Access Compliance Report

Public Rights-of-Way

(Curb Ramps)

Intersection ID: 51369	Main Street: UNIVERSITY_CITY_BV	Cross Street: IKEA_BV	Location: NW
ADA ID: 00631641DCF5	Ramp Type: Perp	Initial Pass/Fail: Fail	Overall Compliance: No
Severity Score: 12.5			
Codes/Mitigation Info/Possible Solution		Field Measurements/Component Compliance

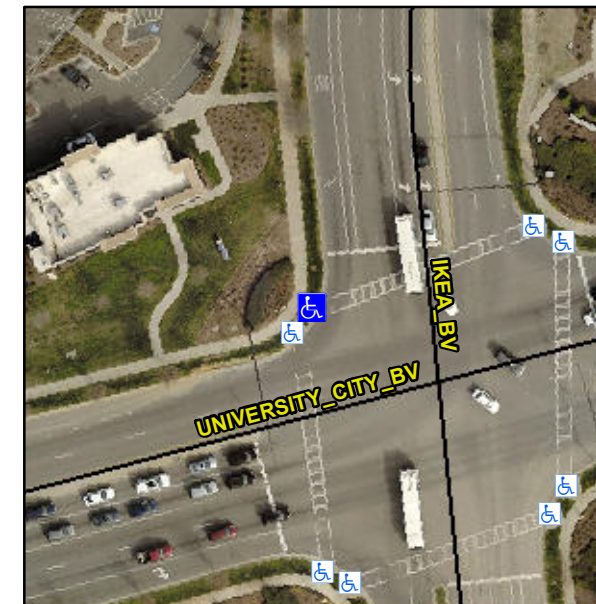
Not Found, R304.2.2

Compliance	Description	Data	Compliance	Description	Data
N/A	Ramp Length (in)	95.0	No	Ramp Slope (%)	8.7
Yes	Ramp Width (in)	48.0	Yes	Ramp XSlope (%)	1.5
N/A	Flare Type LT	N/A	N/A	Flare Type RT	N/A
N/A	Flare Slope LT (%)	N/A	N/A	Flare Slope RT (%)	N/A
N/A	Flare Traversable LT?	N/A	N/A	Flare Traversable RT?	N/A
N/A	Landing Length (in)	N/A	N/A	DWS Provided?	N/A
N/A	Landing Width (in)	N/A	N/A	DWS Contrast?	N/A
N/A	Landing Slope (%)	N/A	N/A	DWS Length (in)	N/A
N/A	Landing X Slope (%)	N/A	N/A	DWS Full Width?	N/A
N/A	Landing Curb? (Y/N)	N/A	N/A	DWS Offset (in)	N/A
N/A	Shared Landing?	N/A			
N/A	Gutter Ponding?	N/A	N/A	Gutter Slope (%)	N/A
N/A	Gutter Lip Ht (in)	N/A	N/A	Gutter X Slope (%)	N/A
N/A	Painted X Walk1?	Yes	N/A	Painted X Walk2?	N/A
	X Walk 1 Direction	To E		X Walk 2 Direction	N/A
N/A	X Walk 1 Width (in)	80.0	N/A	X Walk 2 Width (in)	N/A
	X Walk 1 Slope (%)	1.3		X Walk 2 Slope (%)	N/A
	X Walk 1 X Slope (%)	3.5		X Walk 2 X Slope (%)	N/A

Remove & Replace Entire Ramp.
